August 10, 2017
BOARD OF COUNTY COMMISSIONERS
ORANGE COUNTY, FLORIDA
ADDENDUM NO. 1 / IFB Y17-781 IFB

**PUMP STATIONS 3116 MARTIN CO, 3117 MILLAY DRIVE AND 3216 PADGET
CIRCLE IMPROVEMENTS PACKAGE**

**PS 3216 PADGETT CIR PUMP STATION PLAN,
SECTION, AND DETAILS**

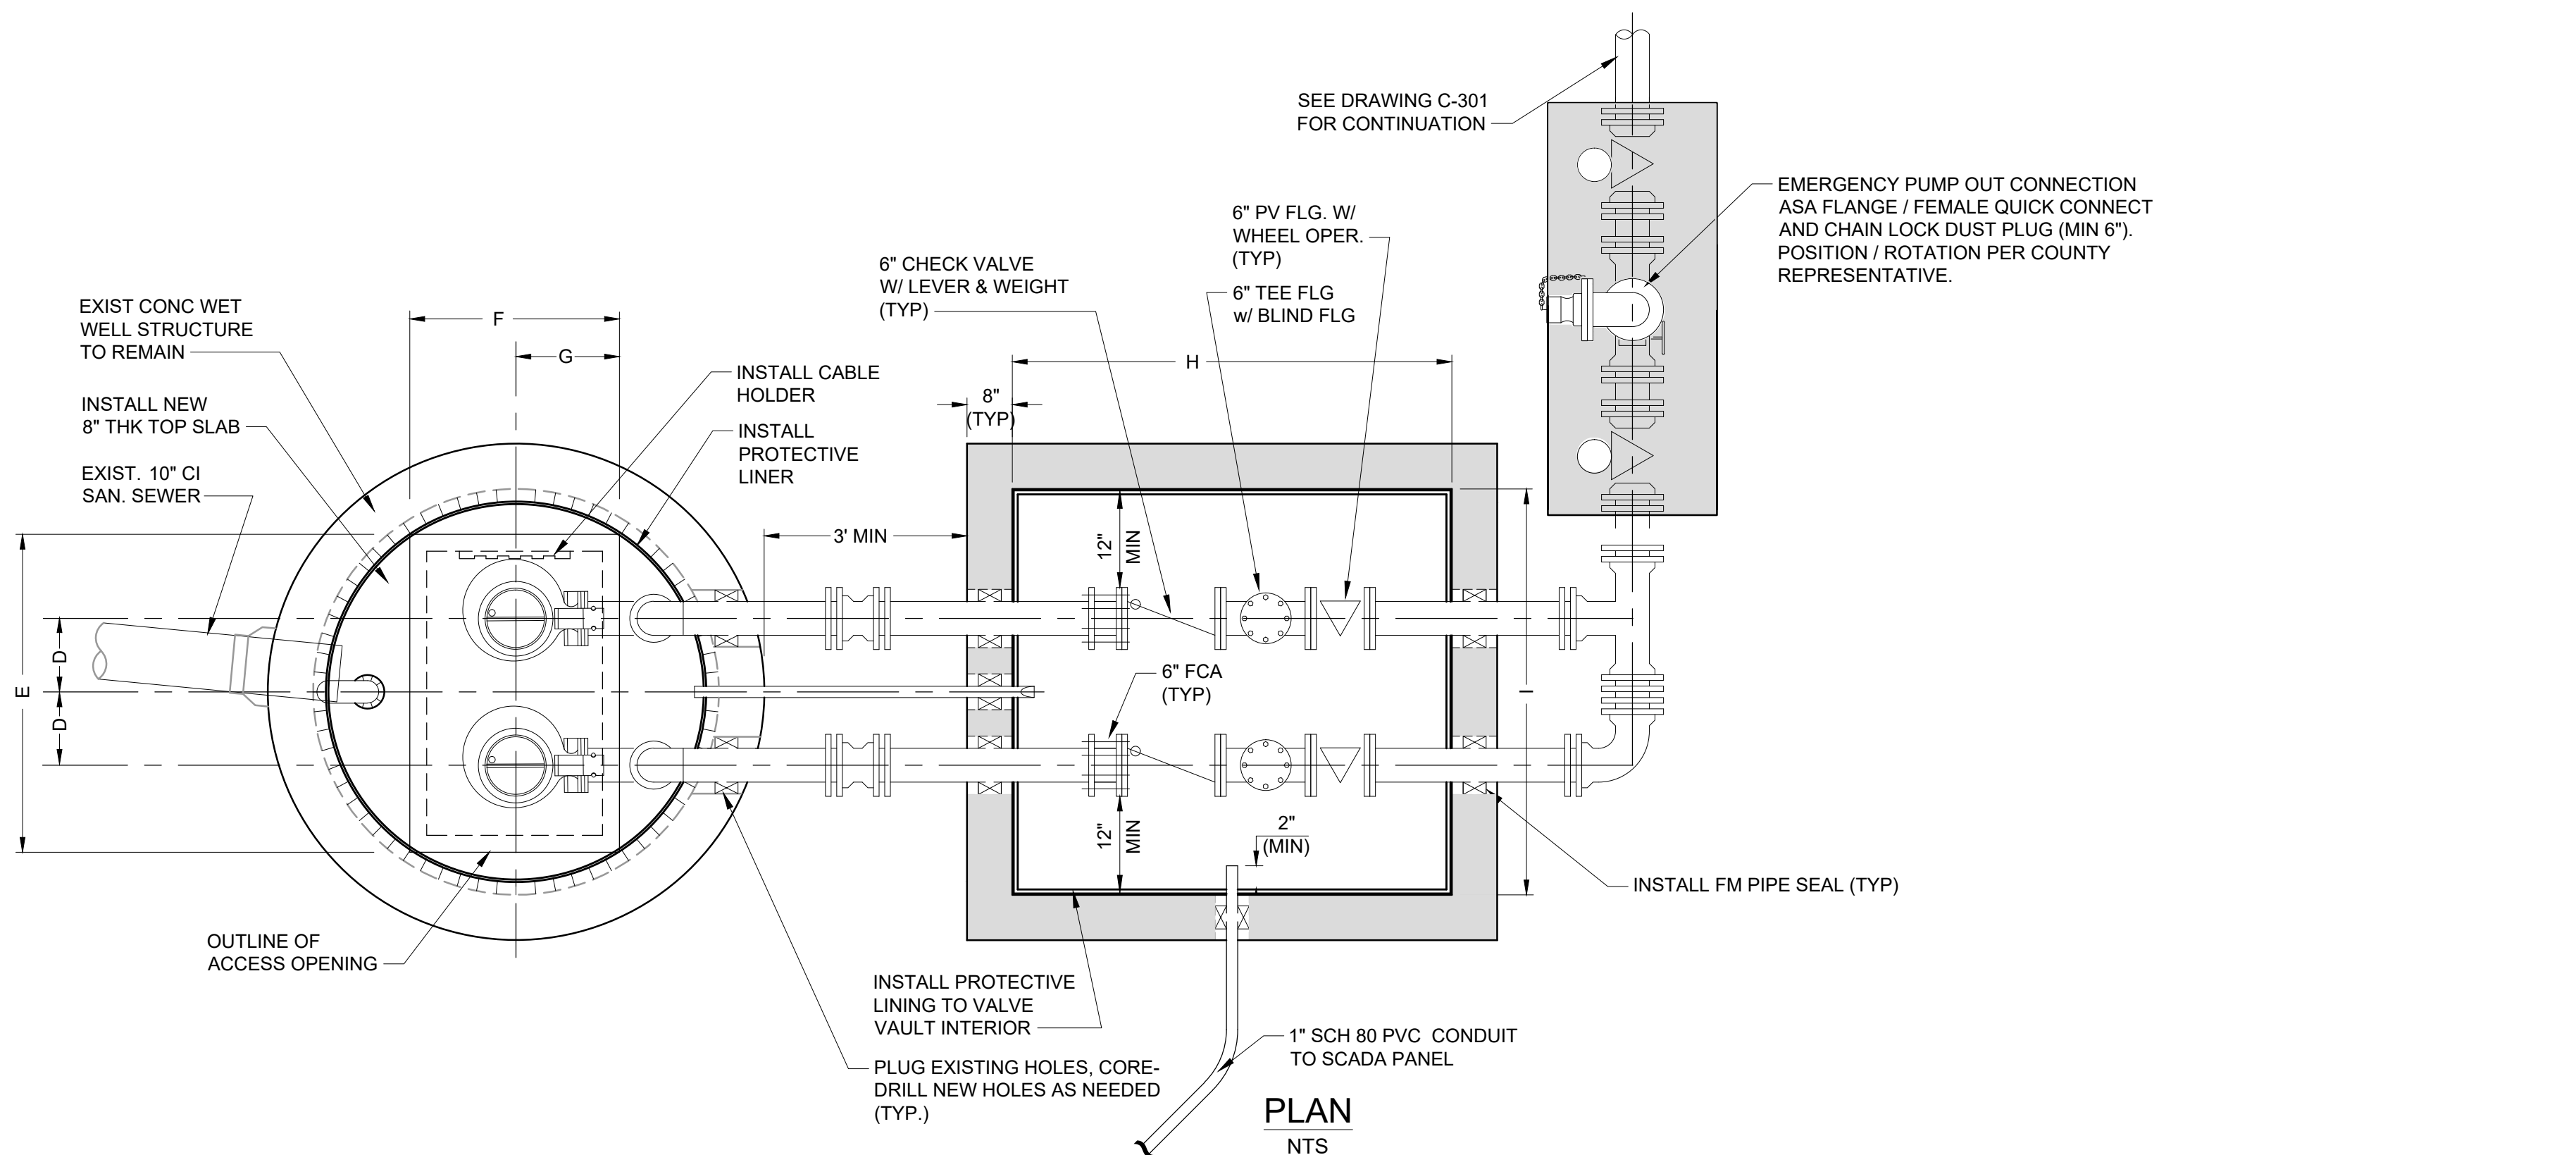
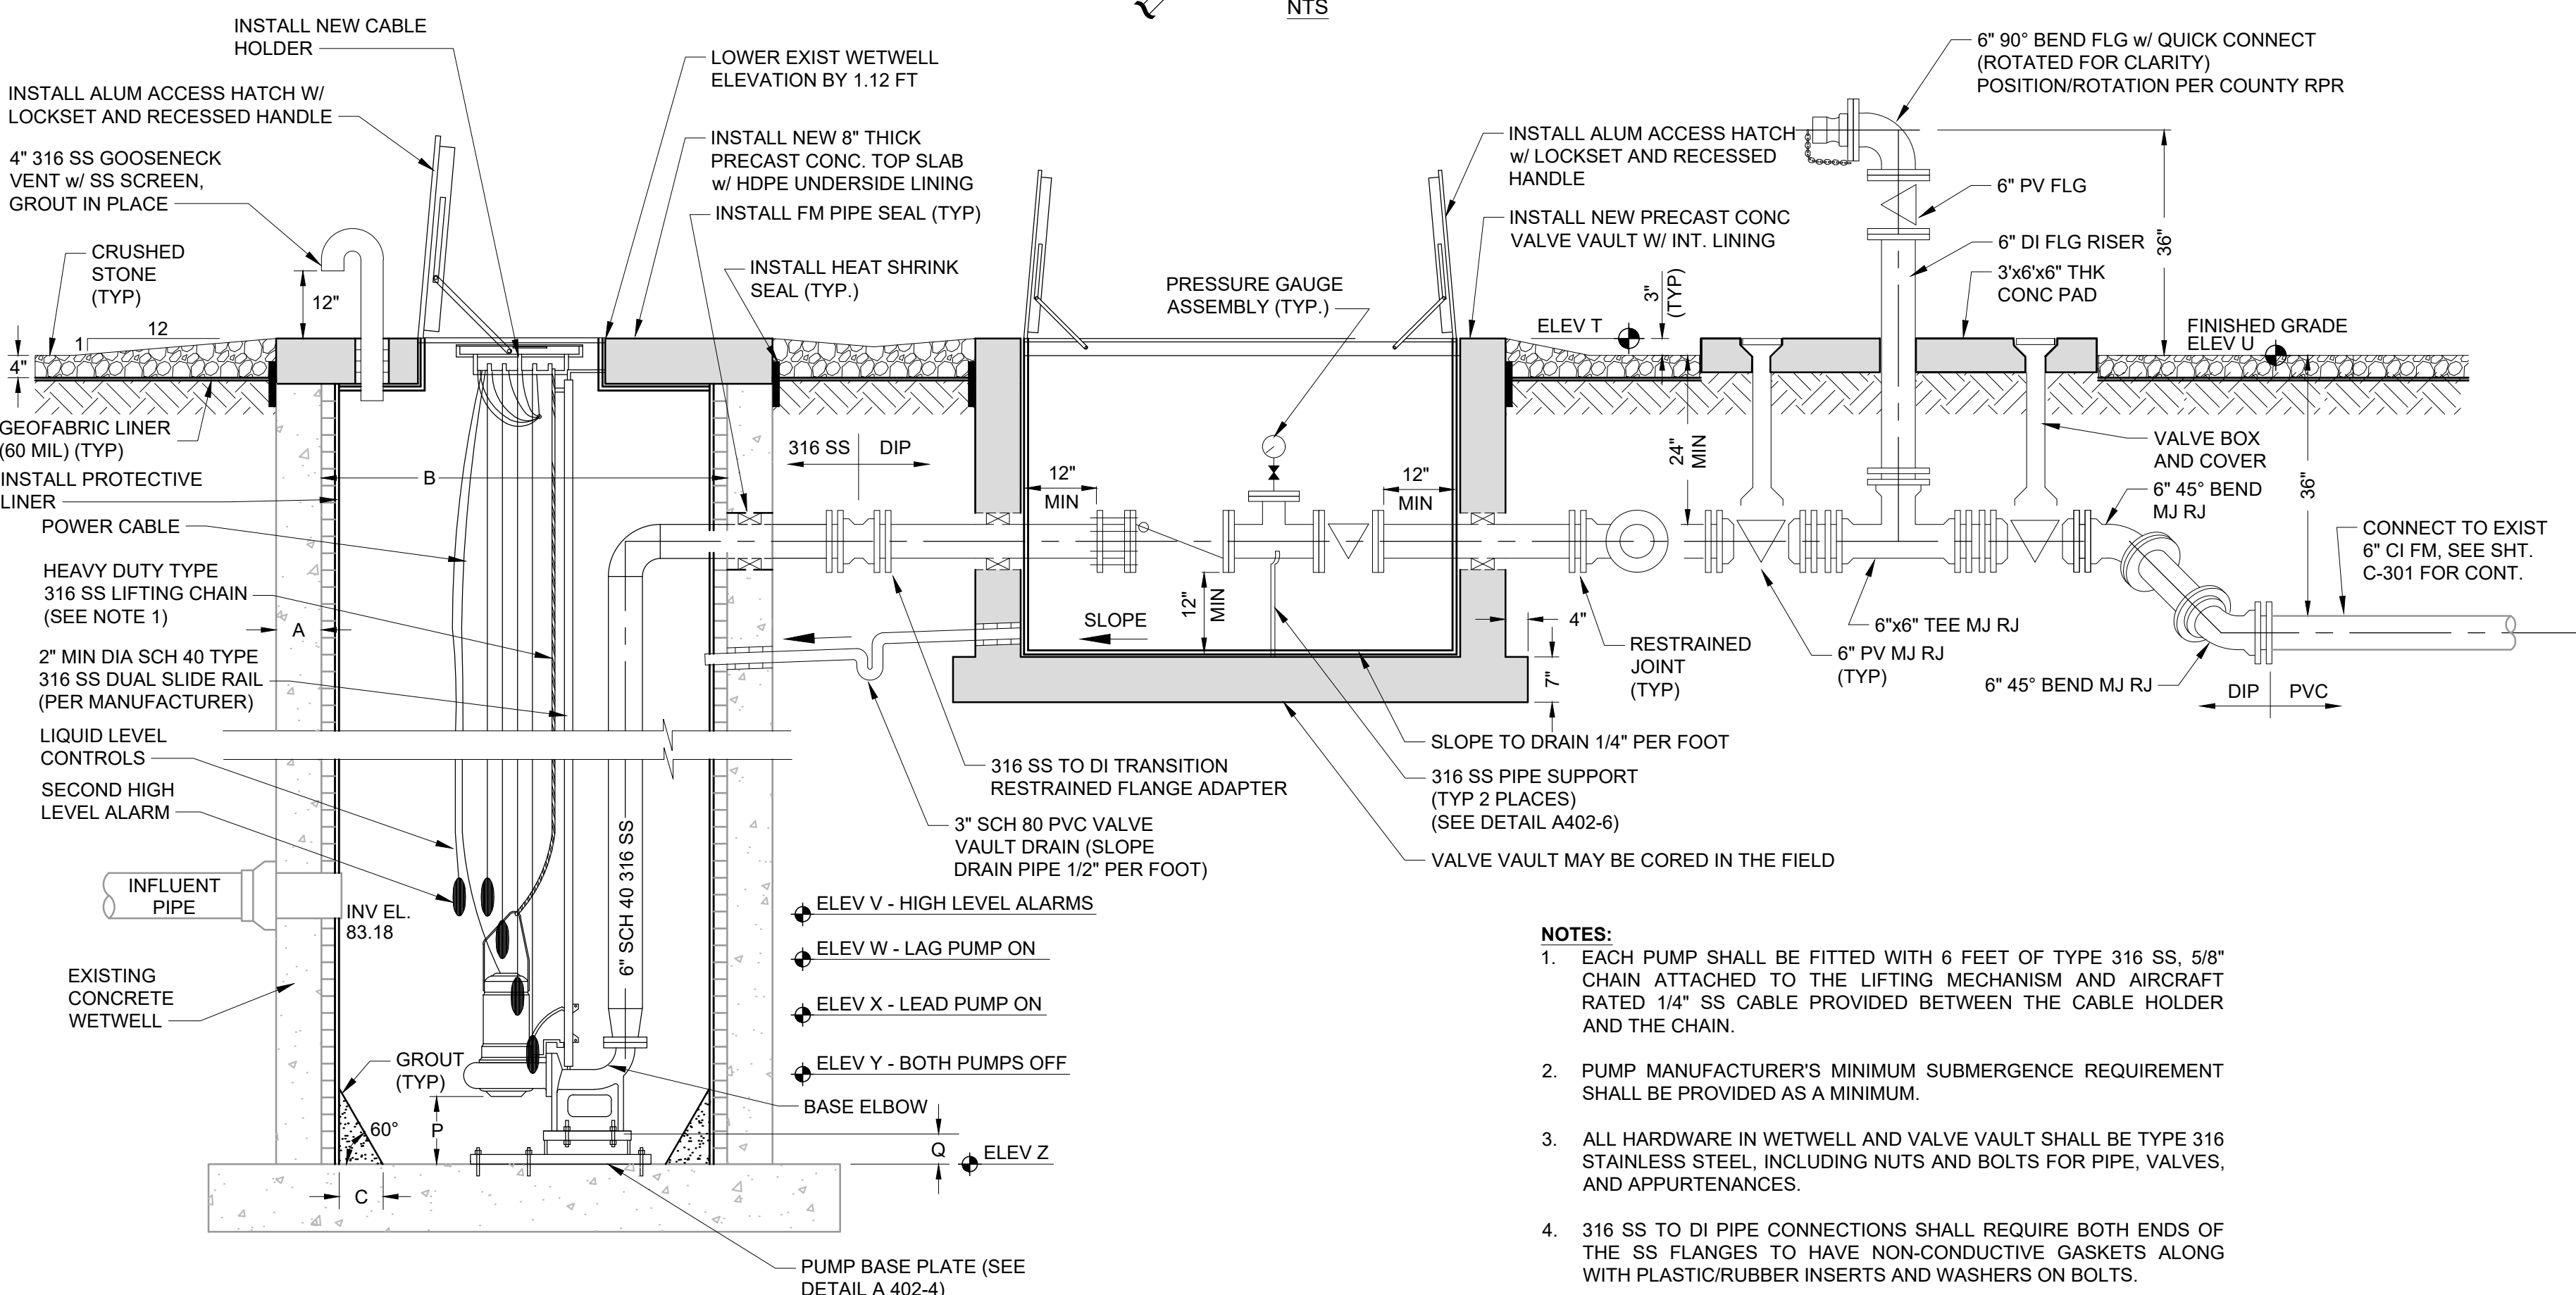
3. Q: Please confirm the top slab elevation of PS 3216. Drawing Sheet C-301 indicates an elevation of 99.65 and the design table on Drawing Sheet P-300 indicates something different in one place.

A: The constructed top slab elevation of PS 3216 should be 96.65. The conflicting call outs have been corrected. Please refer to re-issued Drawing Sheets C-301 and P-300 attached to this Addendum.

DESCRIPTION	SYMBOL	DIM	ELEV.	DIMENSION	ELEV	DESIGN A & B SPECIFICATION NOTES
THICKNESS OF WALL	A	Exist.		Exist.		1. PER PUMP MANUFACTURER REQUIREMENTS
DIAMETER OF WET WELL	B	6'-0"		6'-0"		
WIDTH OF BOTTOM FILLET	C	*1		SEE NOTE 1		2. DIMENSION P AND ELEVATION Y AND Z MUST MEET BOTH PUMP MFR'S REQUIREMENTS
C/L OF WET WELL TO C/L OF PIPES	D	*1		SEE NOTE 1		
LENGTH OF PUMP ACCESS OPENING	E	*1		SEE NOTE 1		3. EL X - EL Z ≥ 5 FEET
WIDTH OF PUMP ACCESS OPENING	F	*1		SEE NOTE 1		
CENTER OF WET WELL TO EDGE OF HATCH	G	*1		SEE NOTE 1		4. TOP ELEVATION OF WETWELL SHALL BE A MIN OF 1 FT ABOVE 100 YR FLOOD ELEVATION AND THE ELEVATION OF THE CROWN OF THE ROAD
VALVE BOX HATCH OPENING	H	6'-6"		6'-6"		
VALVE BOX HATCH OPENING	I	6'-0"		6'-0"		5. SYMBOLS SHOWN IN THE TABLE ARE USED IN THE ADJACENT PUMP STATION PLAN AND SECTION VIEWS
LIP WIDTH OF WET WELL BASE	R	N.A.		N.A.		
THICKNESS OF WET WELL BASE	S	N.A.		N.A.		
TOP OF WET WELL	T		96.65		96.95	96.65
